<b>Docket Number:</b>	21-AFC-02
<b>Project Title:</b>	Willow Rock Energy Storage Center
<b>TN #:</b>	258681
<b>Document Title:</b>	Willow Rock Data Request Set 1 Response Report
<b>Description:</b>	N/A
<b>Filer:</b>	Kathryn Stevens
<b>Organization:</b>	WSP USA Inc.
<b>Submitter Role:</b>	Applicant Consultant
<b>Submission Date:</b>	8/23/2024 4:31:51 PM
<b>Docketed Date:</b>	8/23/2024

# Willow Rock Energy Storage Center (21-AFC-02)

## *Data Request Response Set 1*

## VH Site Map

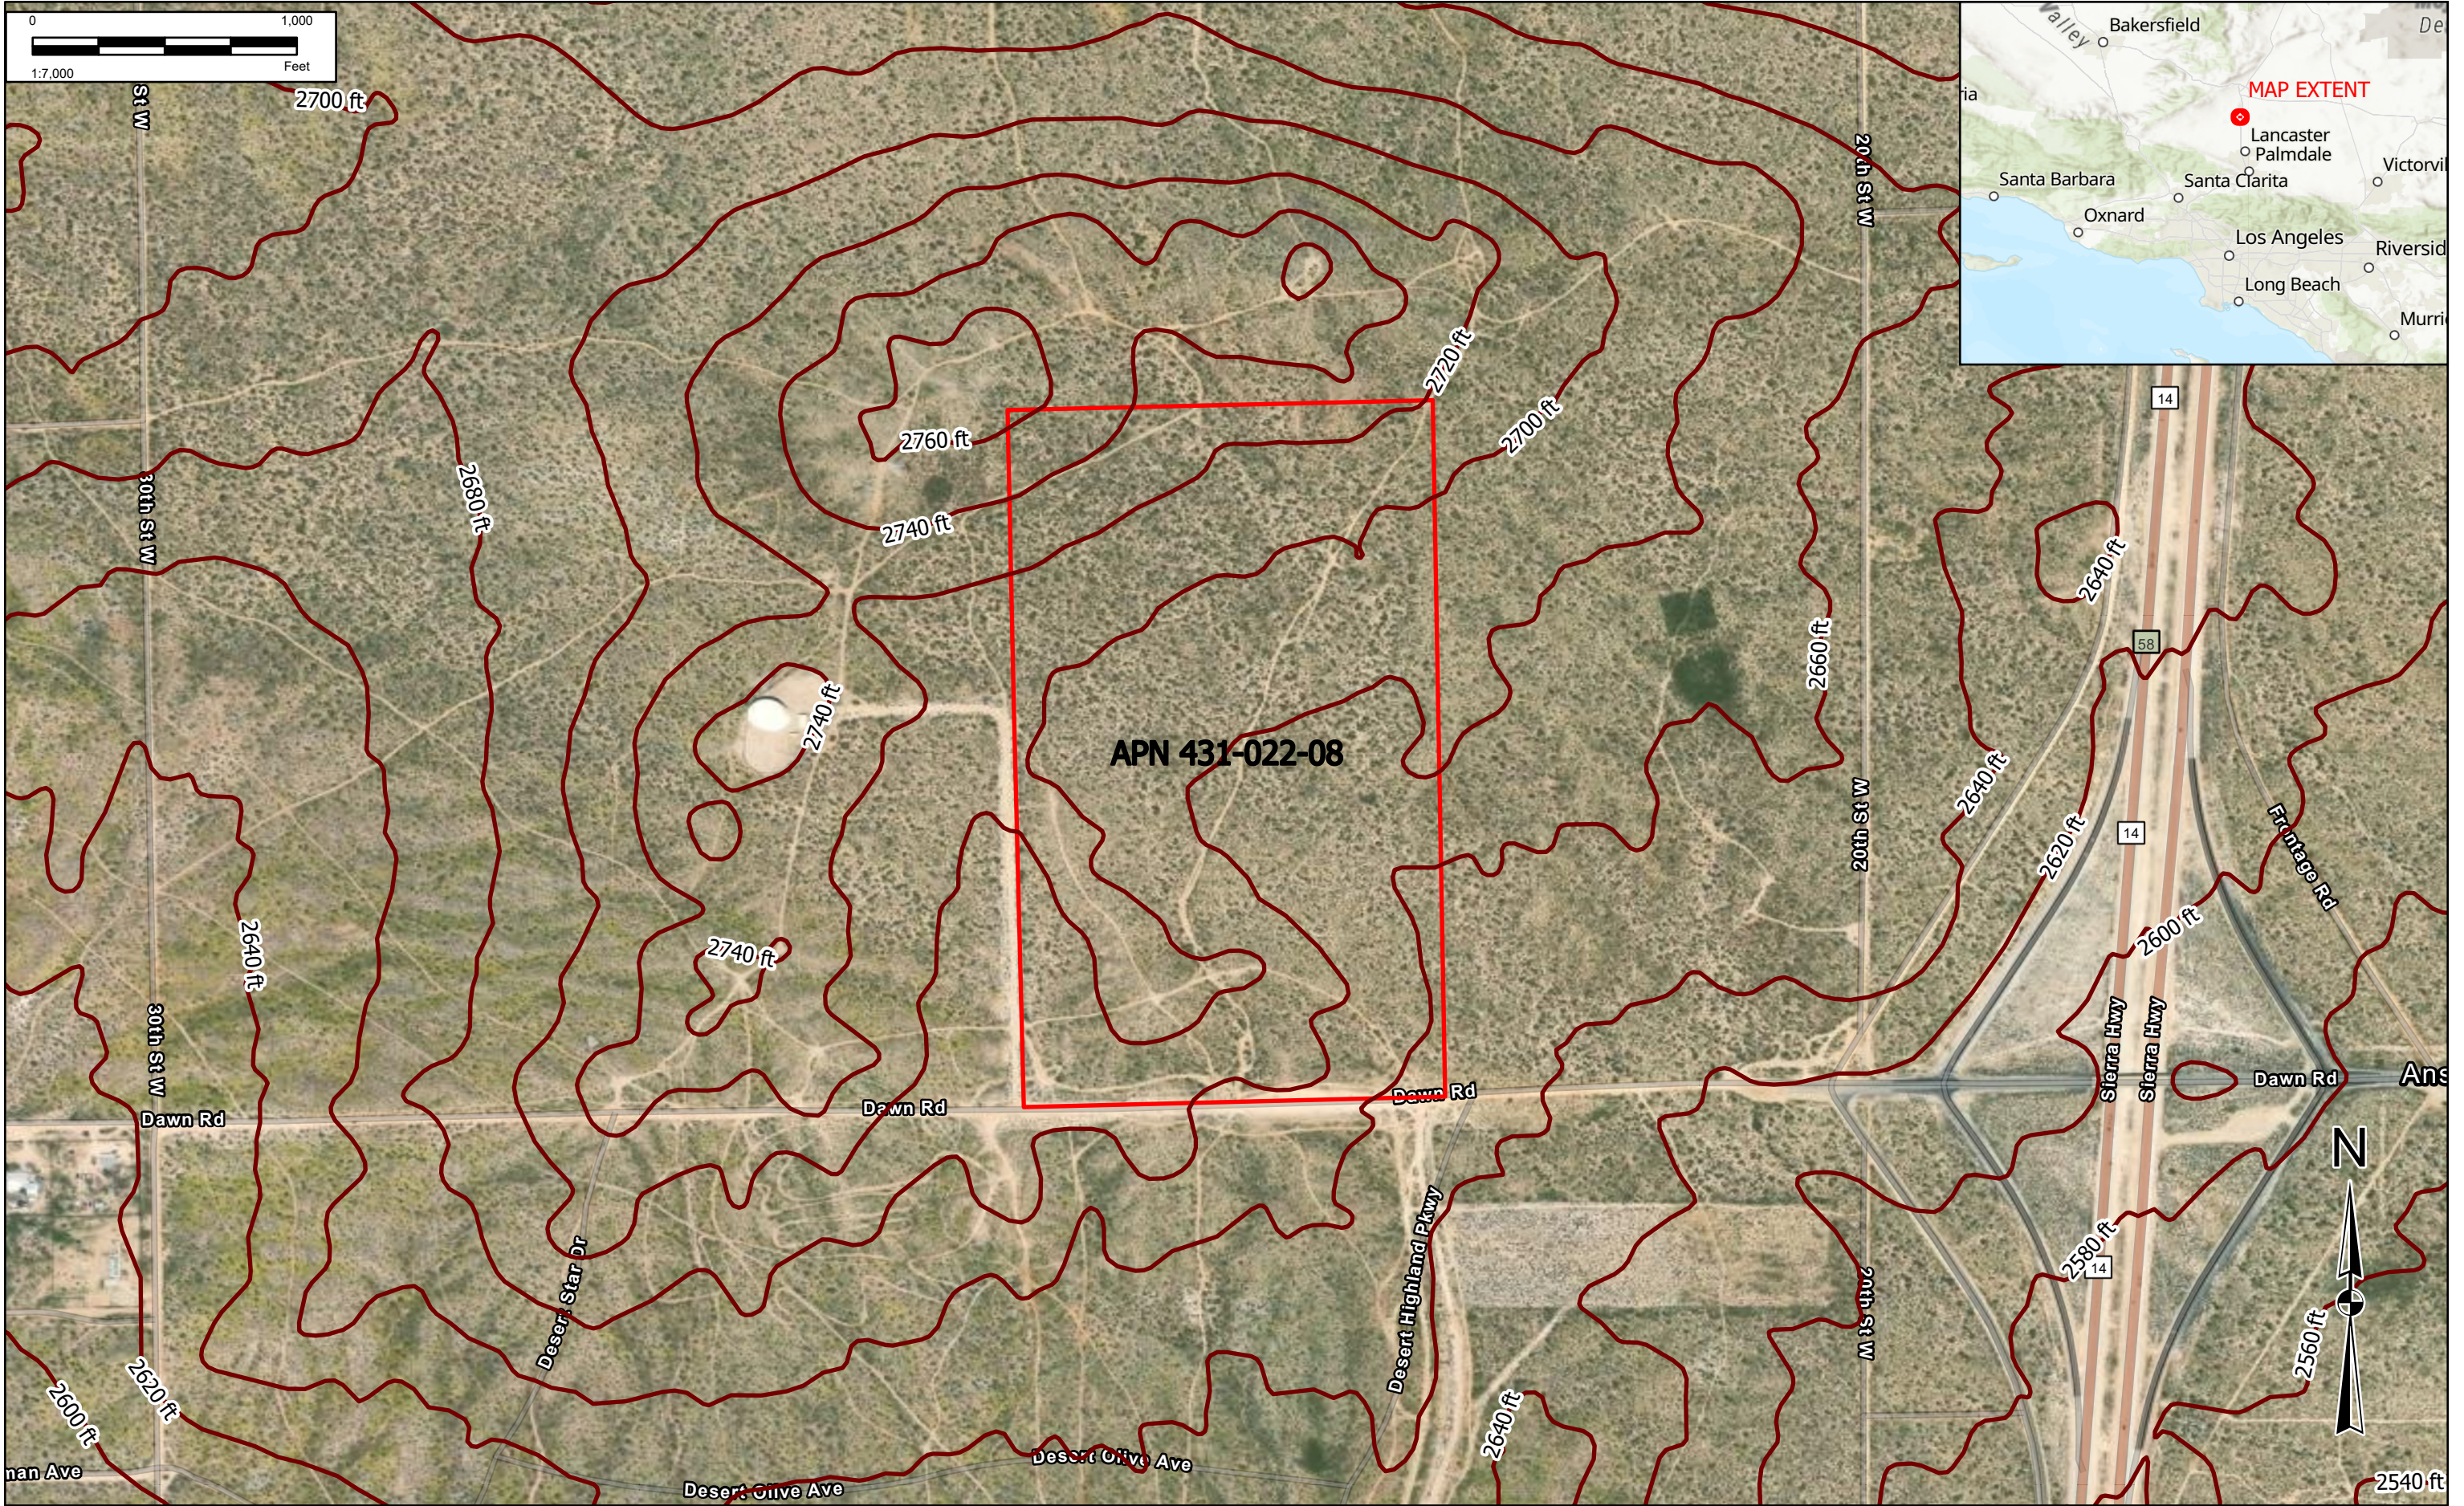
**DR2:** Please provide assessor’s parcel numbers and large-scale, zoomed in maps showing the locations of the VH Site, PS Site, G Site, and OT Site. Please provide any additional details on these sites that might have been acquired by the applicant prior to submittal of the supplemental application (e.g., information from a preliminary site assessment or other similar study).

**Response:** *The assessor’s parcel numbers and large-scale, zoomed in maps showing the locations of VH Site, PS Site, G Site, and OT Site are provided as follows (Attachments DR2-1 through DR2-4):*

- *Attachment DR 2-1 VH Site Map*
- *Attachment DR 2-2 PS Site Map*
- *Attachment DR 2-3 G Site Map*
- *Attachment DR 2-4 OT Site Map*
